## Proof of Evidence (Trees)

### Town and Country Planning Act 1990 Section 78 appeal against the refusal of planning permission

**Appeal:** APP/W0340/W/20/3265460

**Site:** Sandleford Park, Newtown Road, Newbury

#### 4.3.1 Western access point on the AIA impact of scheme 3x Notable trees

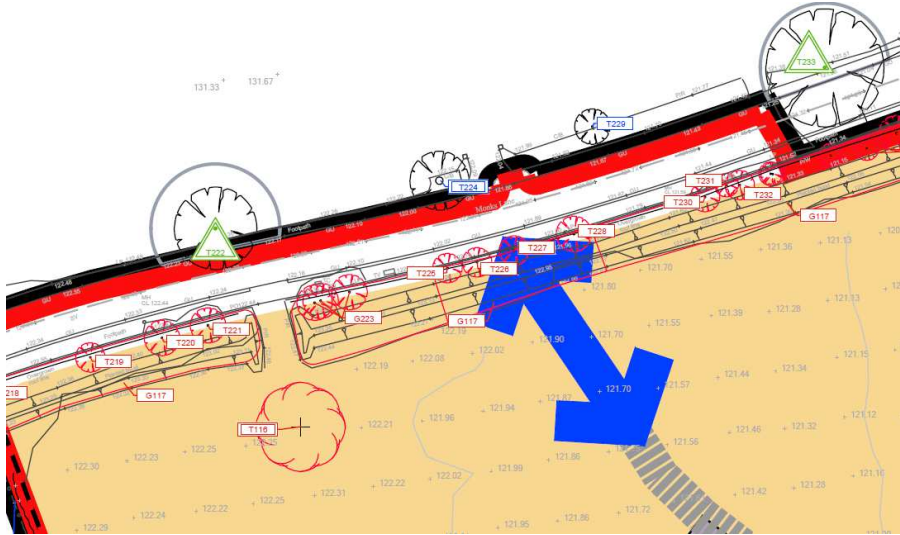
- 4.1 The proposal will result in the extensive loss of trees and hedgerow covered by TPO 201/21/1016 (CD17.6) along Monks Lane without satisfactory strategic mitigation, to the detriment of the amenity, visual quality and verdant character of this important thoroughfare street scene.
- 4.2 There are 3 notable oak trees that will be directly impacted by the proposed access: T116, T222 and T233. Table 4.2.1 below is taken from the Appellant's Arboricultural Impact Assessment (CD1.9); my comments relating to the trees are on the right hand side:

- 4.3 T116 has been identified as a dead oak in accordance with the AIA (ES: Vol 3: Appendices: G11a: Arboricultural Assessment and Method Statement (CD1.9). However, it is a prominent feature along Monks Lane and there is a significant amount of ecological potential as there is a large girth, major trunk cavities, significant decay holes, bark loss and significant amount of deadwood.

- 4.4 As a result of the lack of appropriate provision for preservation and planting of trees as set out in the Town and Country Planning Act 1990 (as amended) section 197, the Council had significant concerns and, consequently, TPO 201/21/1016 (W13) (CD17.6) was served on the trees along Monks Lane to prohibit the cutting down of important trees without securing sufficient space for replacement planting to mitigate against their loss.
- 4.5 Tree T116 (TPO 201/21/1016 (T12) (CD17.6) is showing characteristics such as major deadwood in the branches and stem, flaking bark of a veteran/senescent stage tree and should be retained as an important feature and allowed sufficient space to decay naturally.
- 4.6 The proposal also requires the removal of 250 metres of hedgerow and trees along Monks Lane without securing sufficient space for the replacement planting.

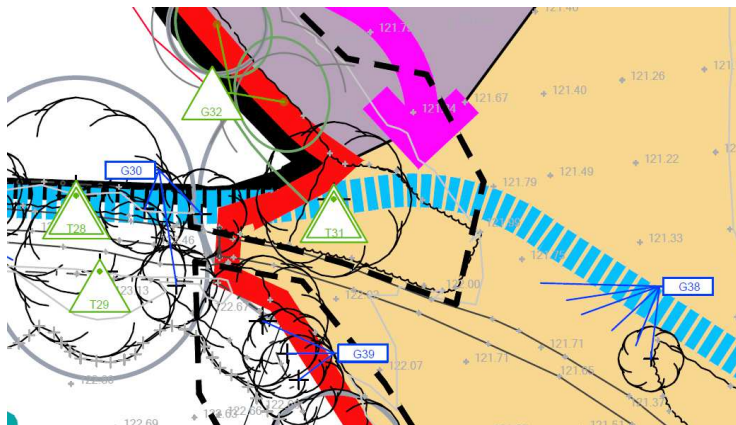
- 6.16 The site has an abundance of Ancient/Veteran trees and the current proposed layout will involve the loss and the direct impact within the RPAs of ancient and veteran trees by development. The development is not deemed a wholly exception reason under the NPPF paragraph 175C.

- 6.17 Sandeiford SPD states: *'All-important existing trees and hedgerows will be retained and integrated into the development'*. Space needs to be provided within the development to allow for the proper growth and establishment of both existing and proposed trees.

### 7.3.1 Direct Impact of access road on veteran tree

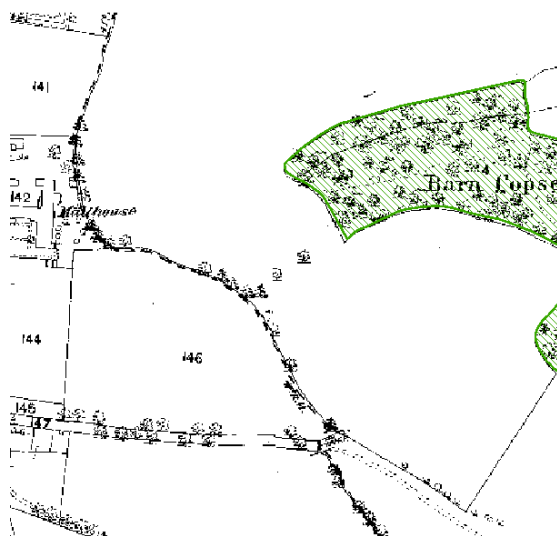
- 7.3 The emergency access goes through the centre of a veteran tree marked as T31 on the AIA:

The Emergency access upgrade to 3.75 metre bonded surface along Greenham 9 footpath will directly impact a number of trees including some notable trees and some trees identified on the Ancient Tree Inventory as veteran, the trees are as identified on the AIA:
